CITY OF PORTLAND BUILDING PERMIT

Job ID: 2011-07-1652-ALTR

Permit - 2011-07-1652
amendment - 2011-12859

RE: 93 Westland Avenue Renovation project

SK-1
1 OF 5

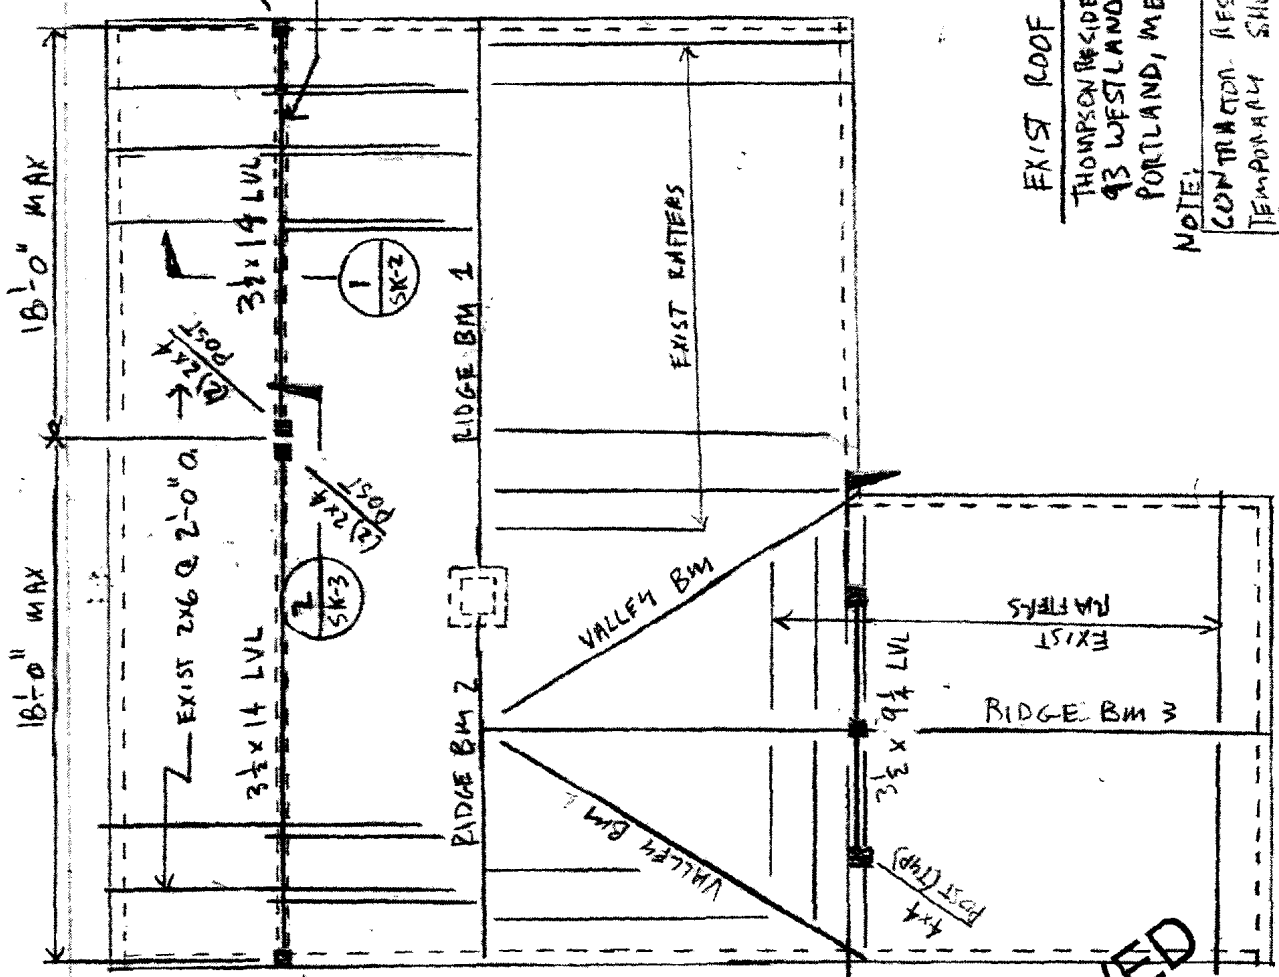
The first item I reviewed was a ridge beam running from the southwest side of the house (labeled Ridge Beam 3 on Sketch SK-1). The ridge beam is a 1 3/4" x 11 7/8" LVL, and spans approximately 23'-0". This existing ridge beam was found to be overstressed according to current building code requirements. It is recommended that the contractor install a vertical support to reduce the span of the ridge beam to meet current building code requirements. The installation of this support is detailed on the attached sketches.

The second issue I reviewed was the roof rafters on the North side of the building. The original roof was reportedly lifted at the ridgeline to allow for more living space on the second floor. The rafters currently bear on the exterior wall at one end, a new knee wall at center span, and a new ridge beam at the other end. The new knee wall at center span is supported by the second floor framing. New rafters were sistered alongside the existing rafters to span from the knee wall to the center ridgeline. Upon review of this framing for code compliance, I found that the floor below the knee wall lacked the structural capacity to carry the roof loads from above. I recommend removing the existing knee wall and installing two LVL beams to remove the roof load from the existing floor framing. Details of this recommended repair are shown on the attached sketches.
